# BID Addendum No. 3

March 15, 2021

**Bedford Fire Headquarters  
550 Old Post Road  
Bedford, NY 10506**

**S1.1**

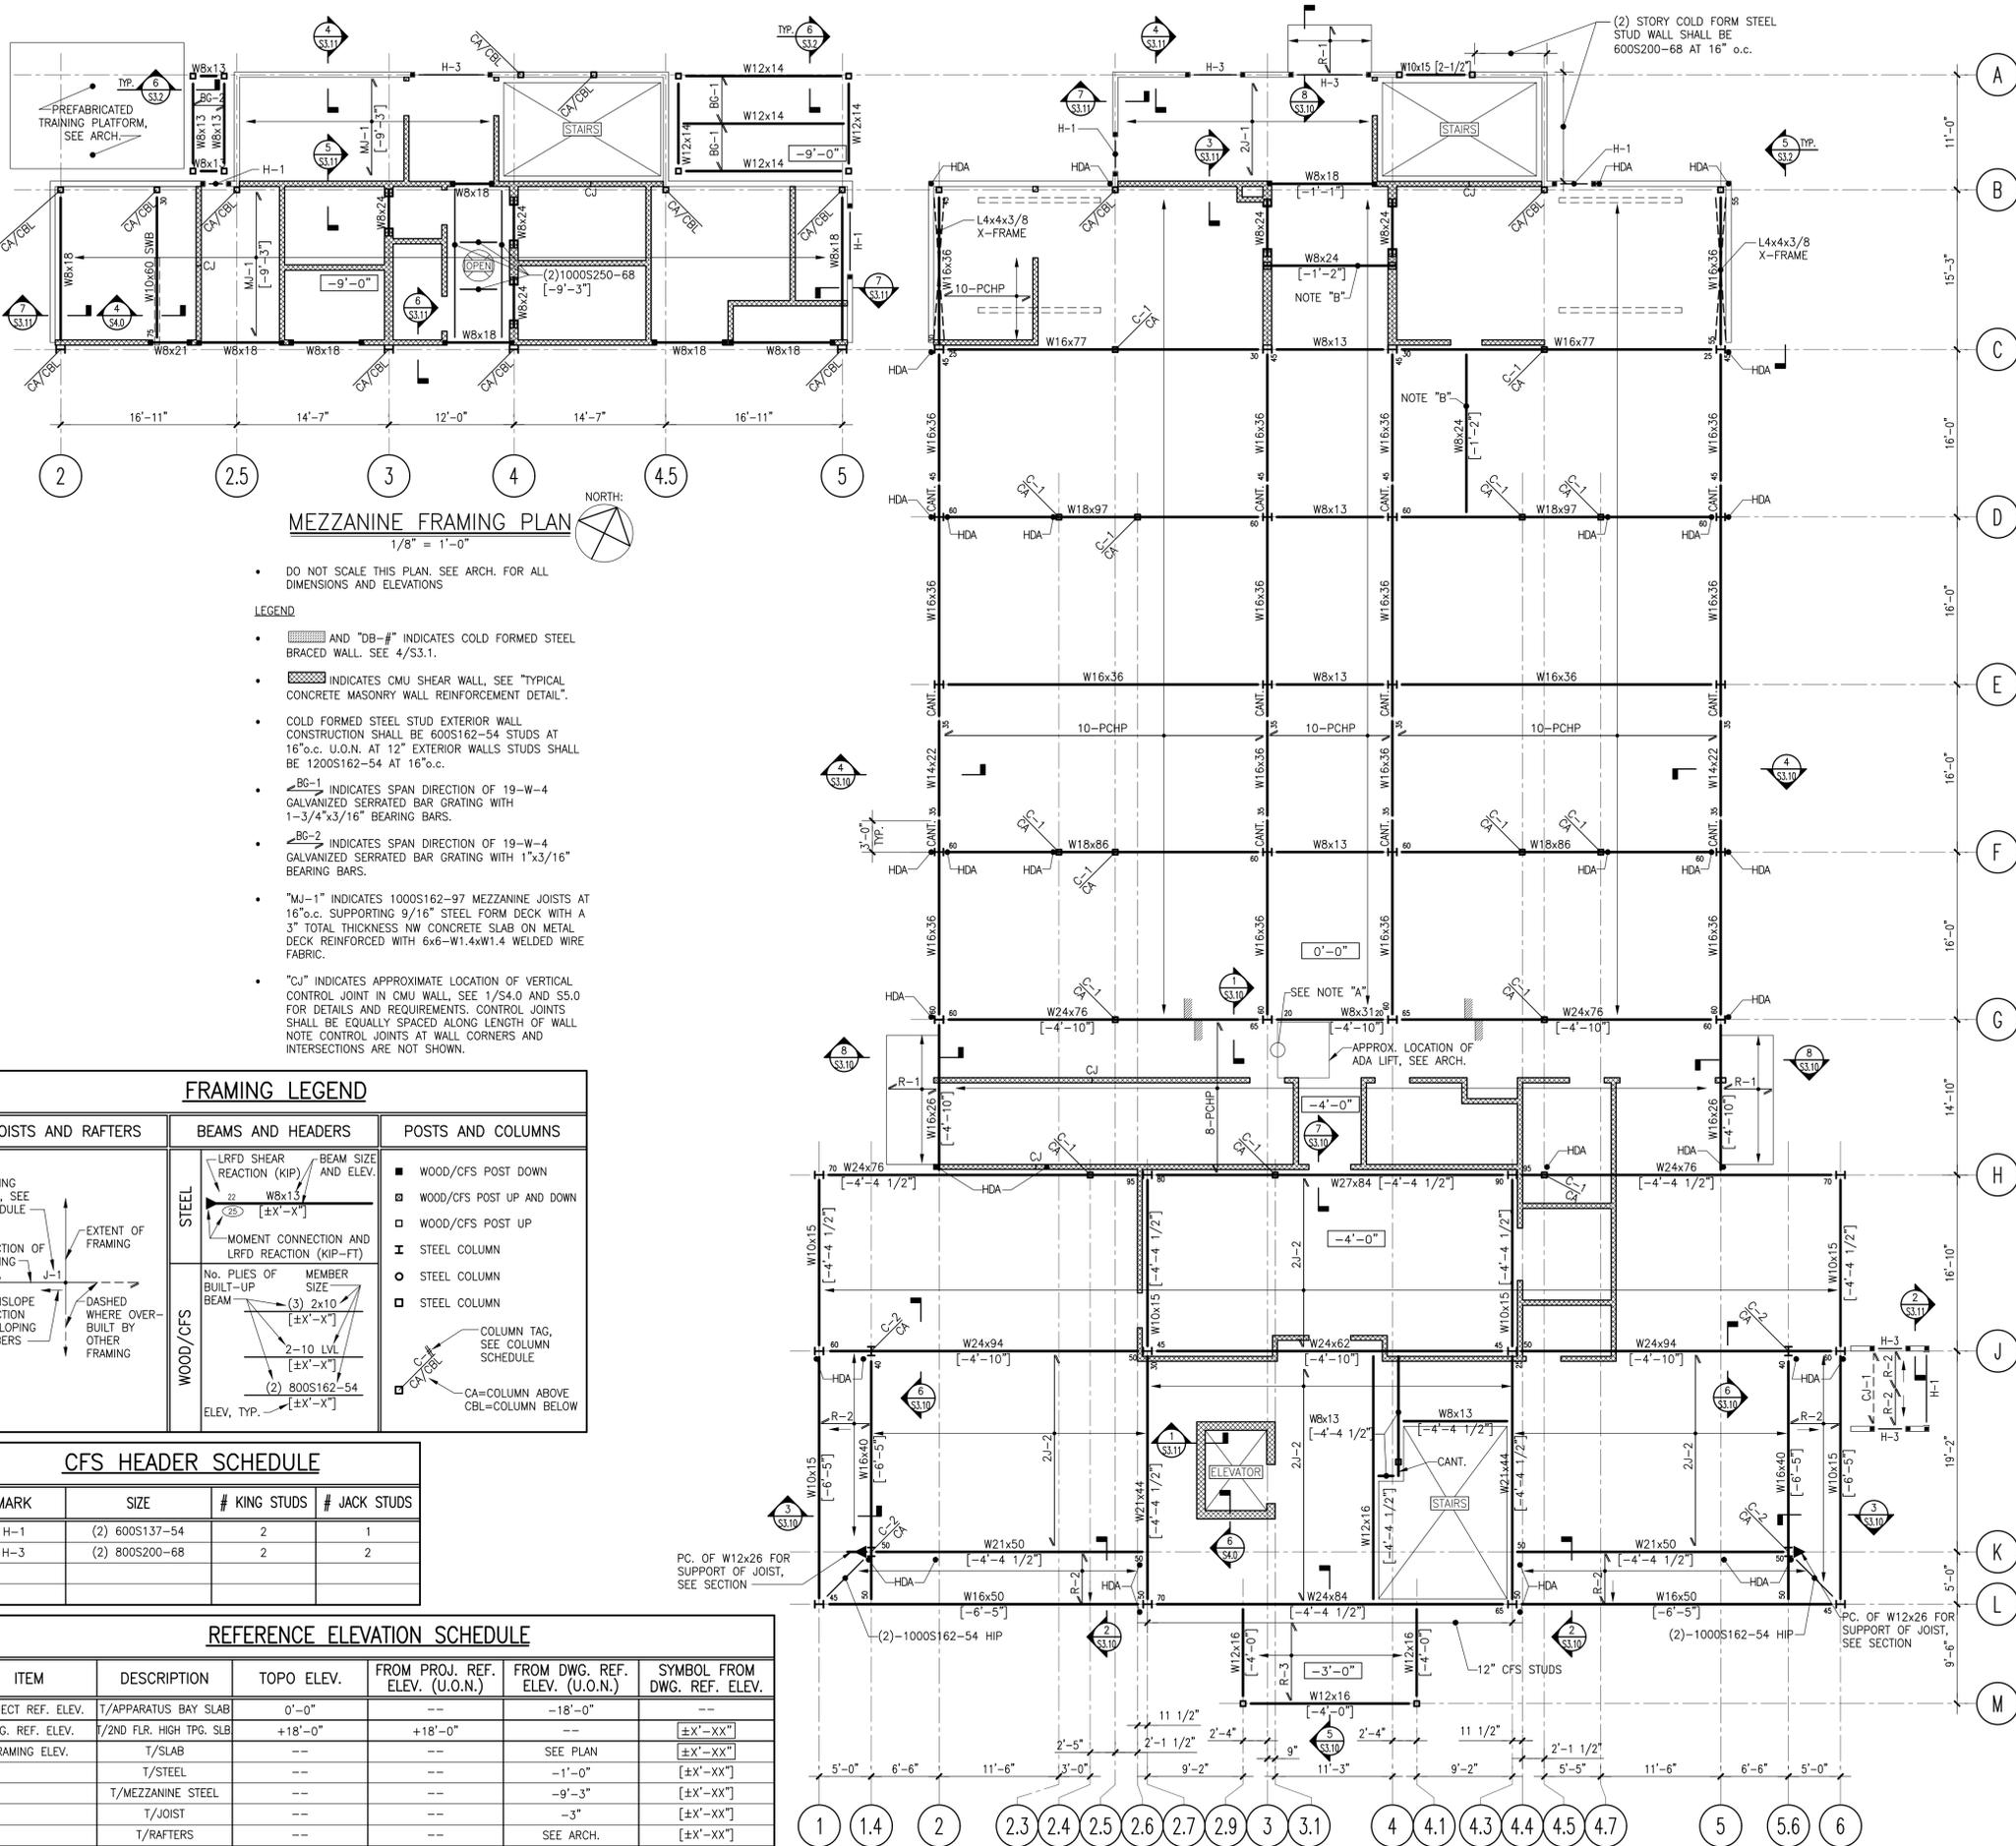
1. Drawing 4/21 – Delete the gas line from the propane tanks to the Future Storage Building. This will be handled by the owner.
2. Drawing S1.1- Delete drawing S1.1 in set and replace with the attached revised Drawing S1.1.

03.15.21 REVISED SLAB REINFORCEMENT
